RE: Notification of Construction Completion on telecommunication facilities

RE: Notice of Work Complete
277 Huckleberry Hill Road
Avon, CT 06013
Sprint Site #: NV2.5_CT33XC589

Subject: Modification Inspection Report

PROJECT DESCRIPTION:
**MODIFICATION DRAWINGS
FOR A 100' LAMINATED WOOD POLE**

SHEET NUMBER
S-1

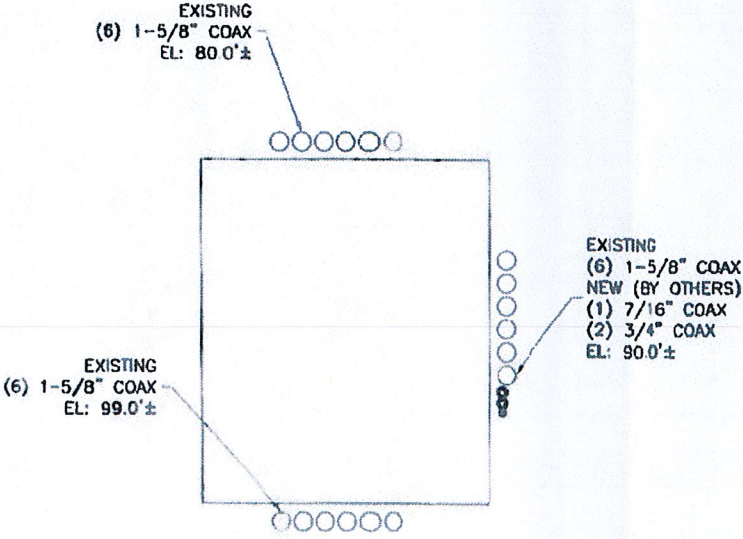
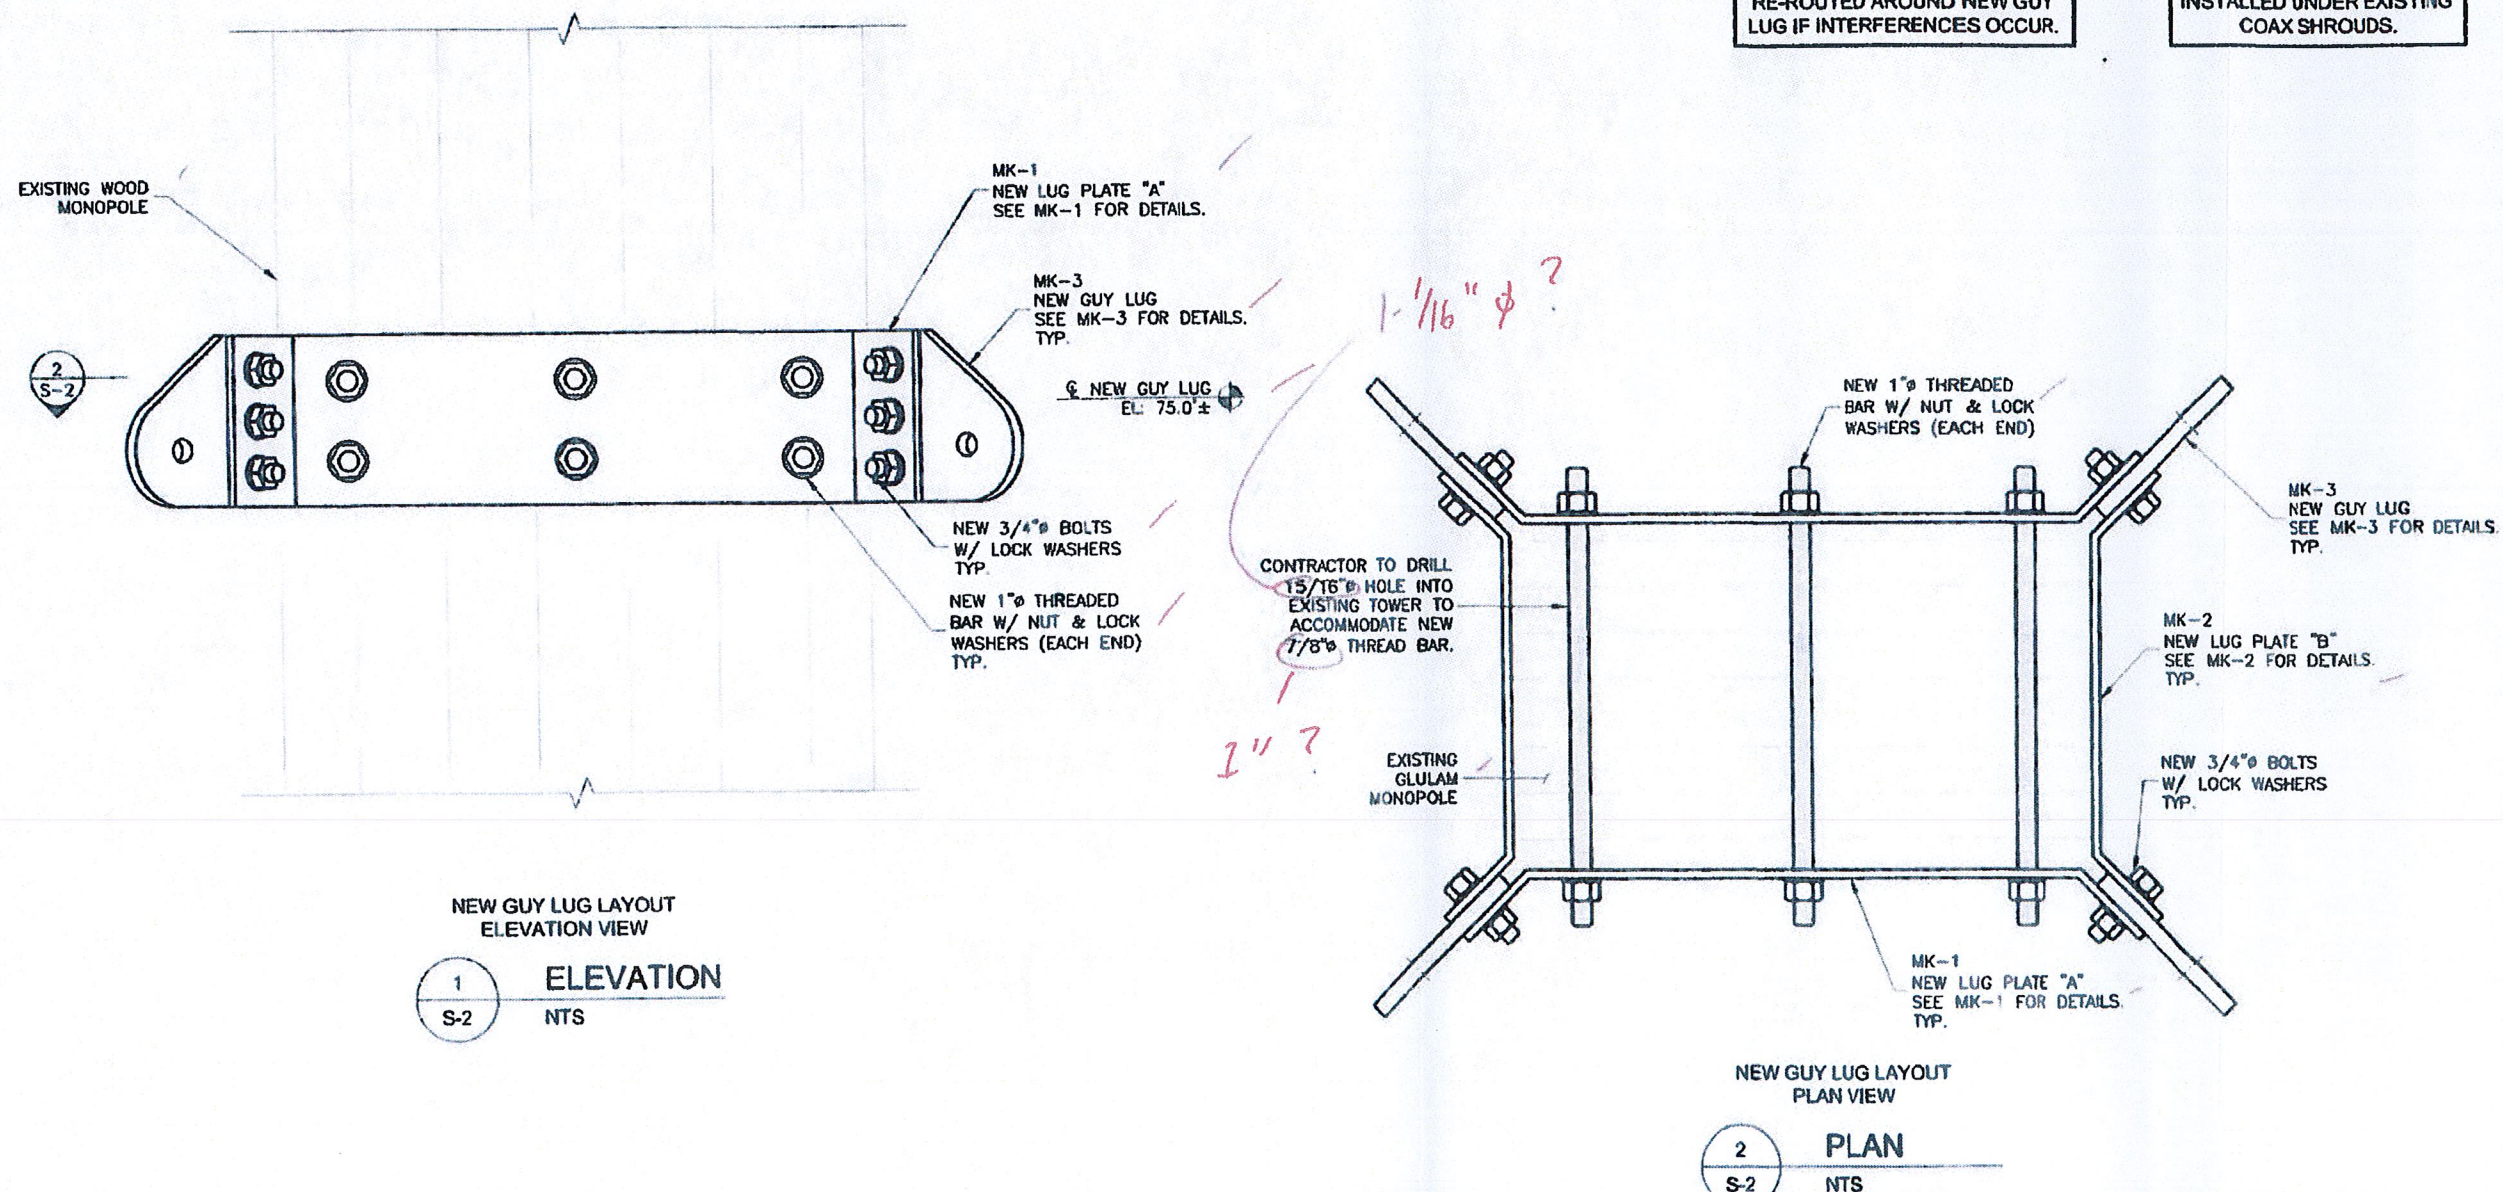
NOTE:?
TYP. install detail for anchors A, B, & D.

EXISTING SAFETY CABLE TO BE RE-ROUTED AROUND NEW GUY LUG IF INTERFERENCES OCCUR.

NEW LUG PLATES TO BE INSTALLED UNDER EXISTING COAX SHROUDS.

SHEET NUMBER
S-5

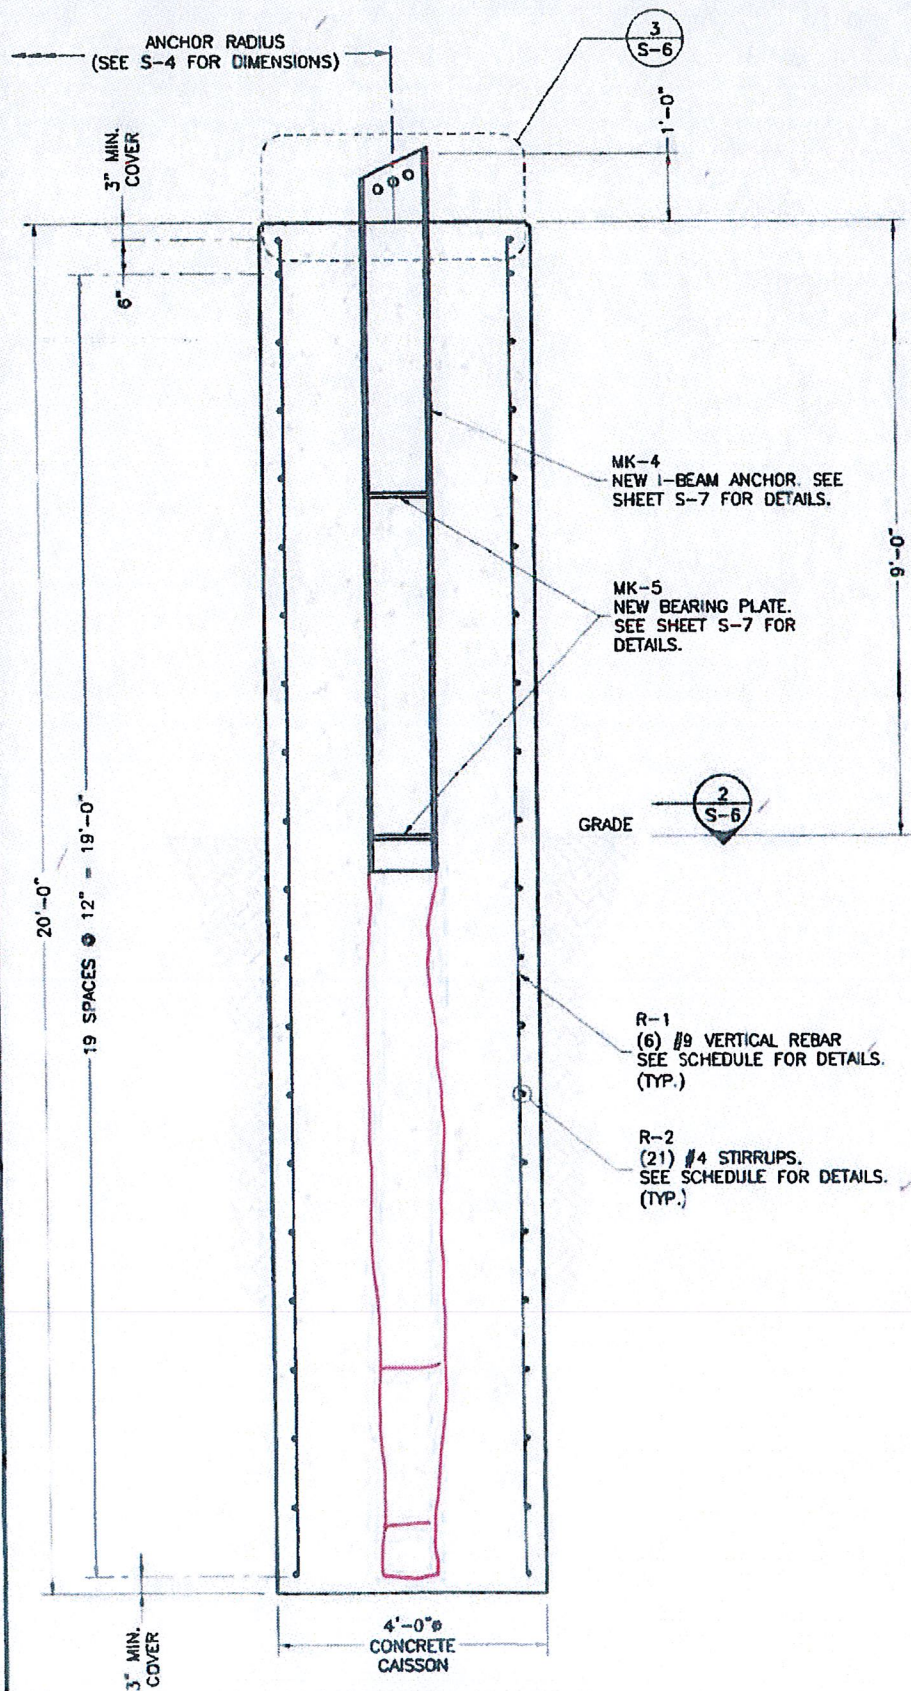
Add -> TYP. OF ANCHOR A, B, C

SHEET NUMBER
S-6

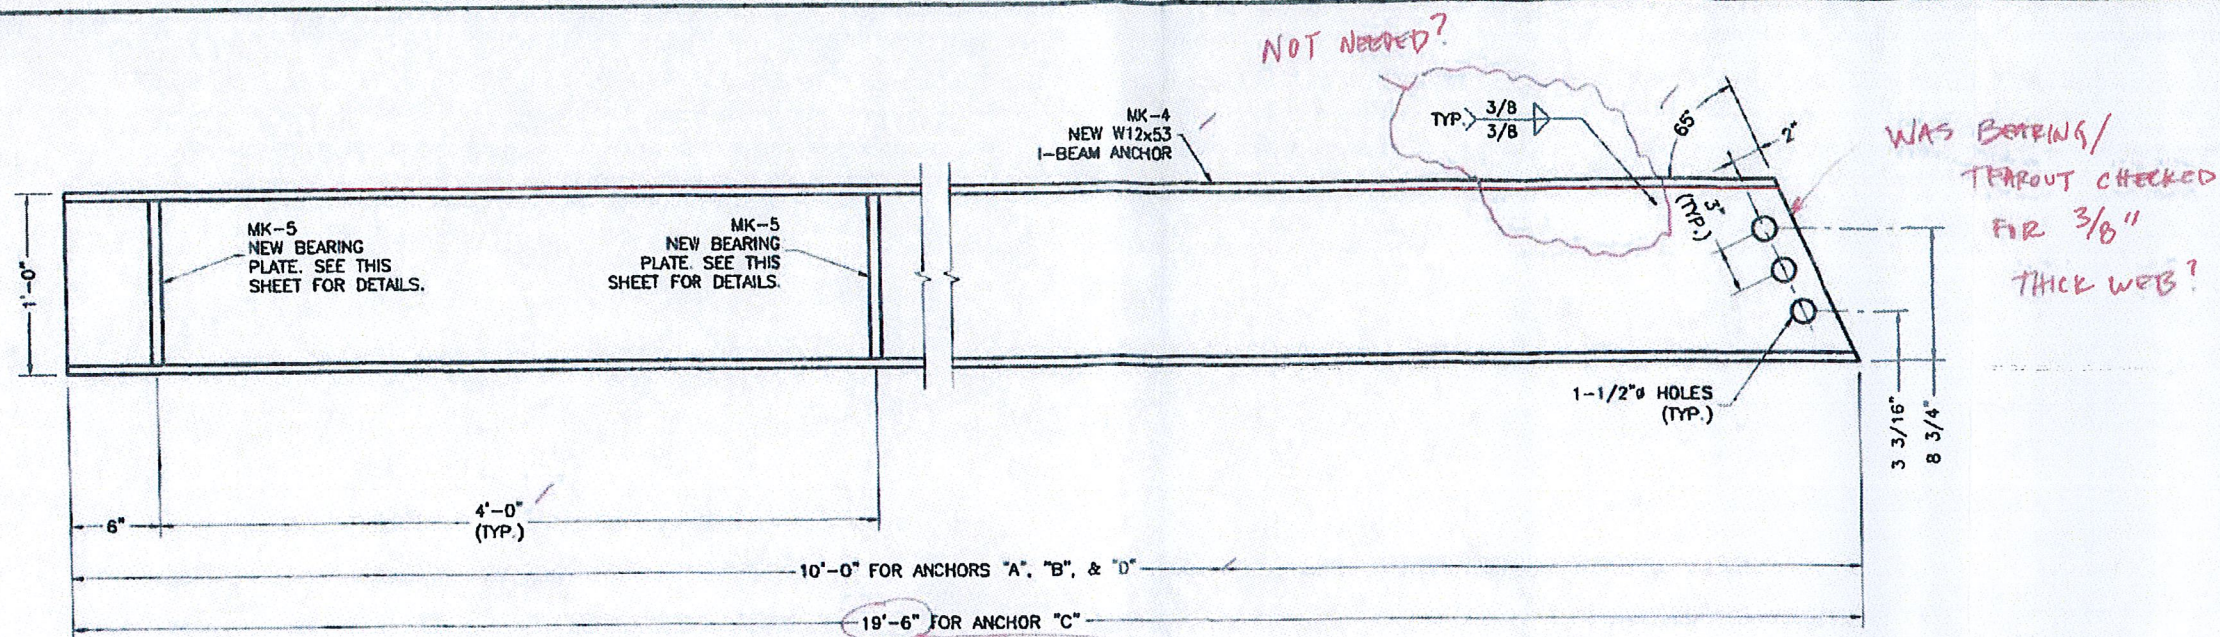
Add → Anchor C ONLY

SHEET NUMBER
S-7

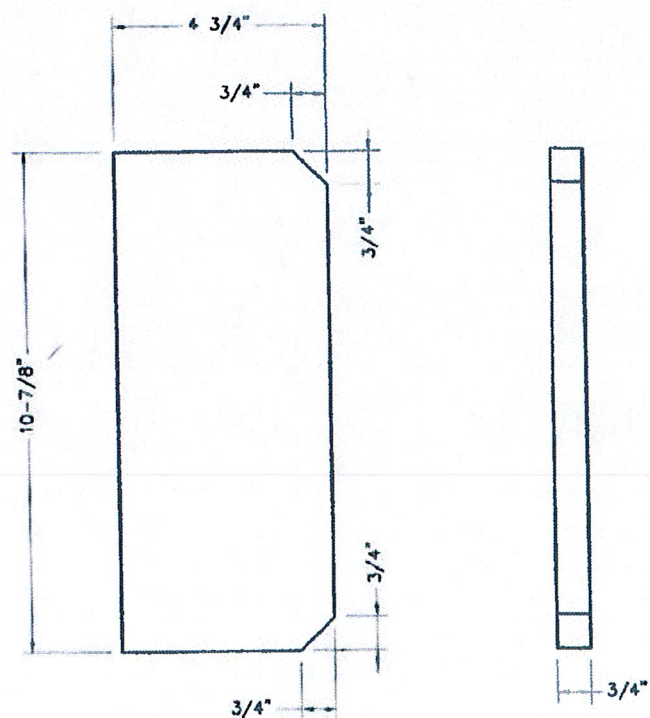
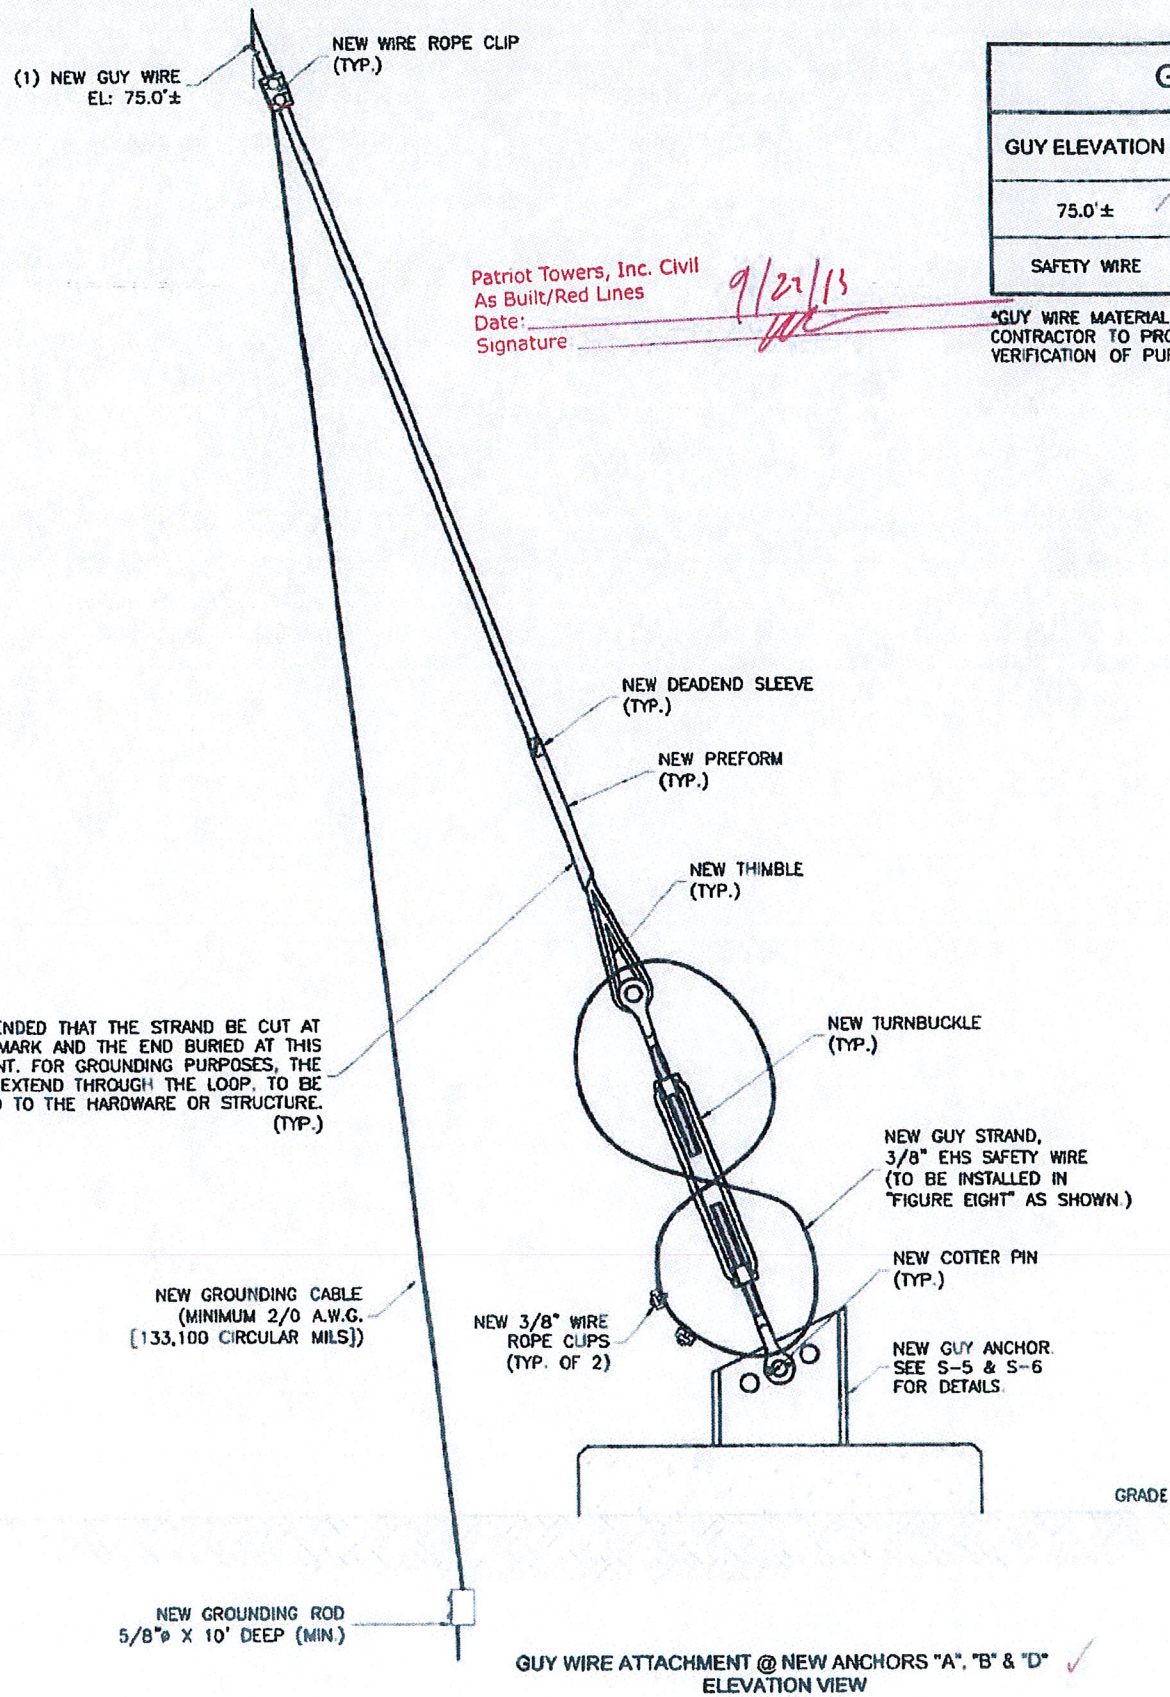
ONLY SHOWING IT 10' ON SHEET S-6
